# PERMIT

A REPAIR

SEWAGE DISPOSAL SYSTEM

ROAD 1105 River Road

PERMIT CARD NW

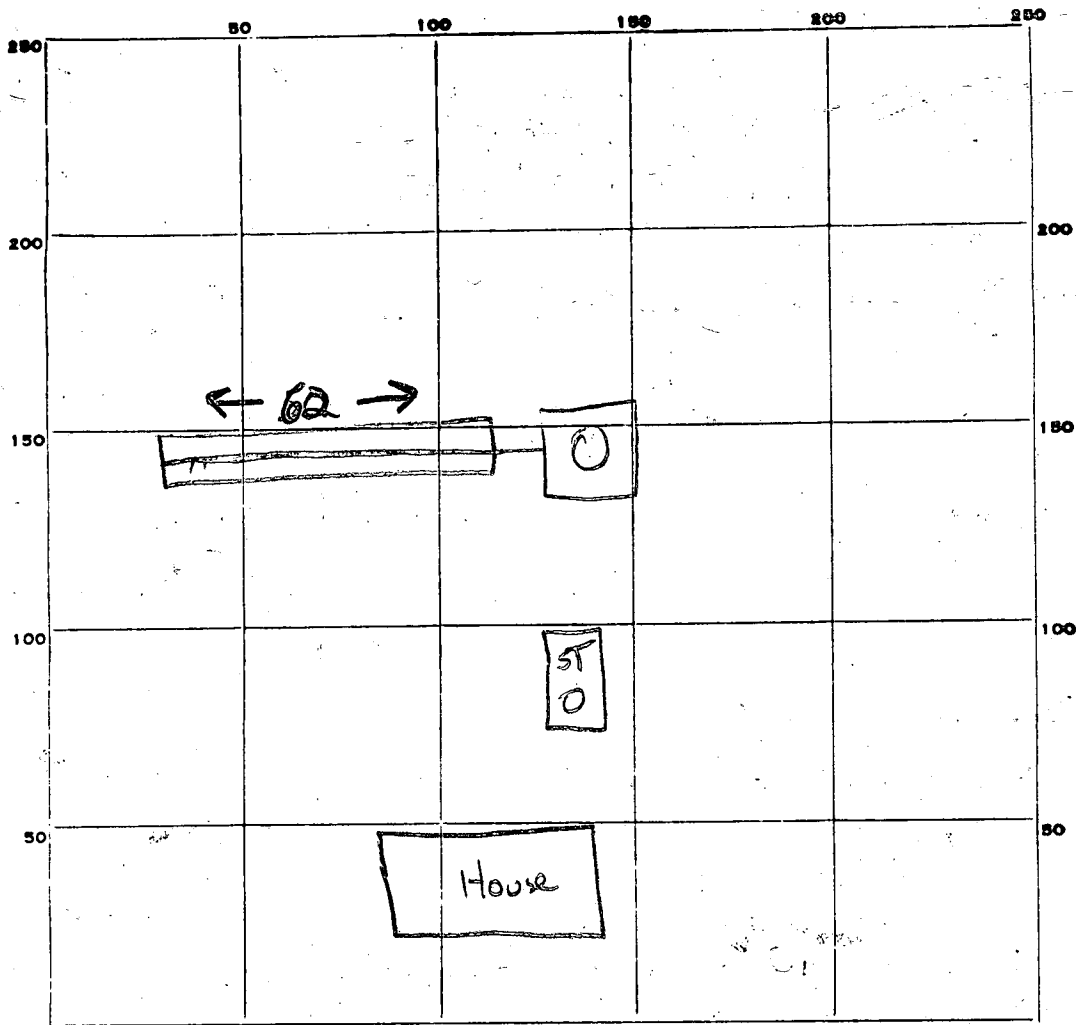
REMARKS 14 Aug 78 - Specs. written. OK to add gravel to trench  
if owners will certify depth of trench (GLK)  
15 Aug 78 - Final OK - Cover all work (GLK)

DATE SYSTEM APPROVED 15 Aug. 78
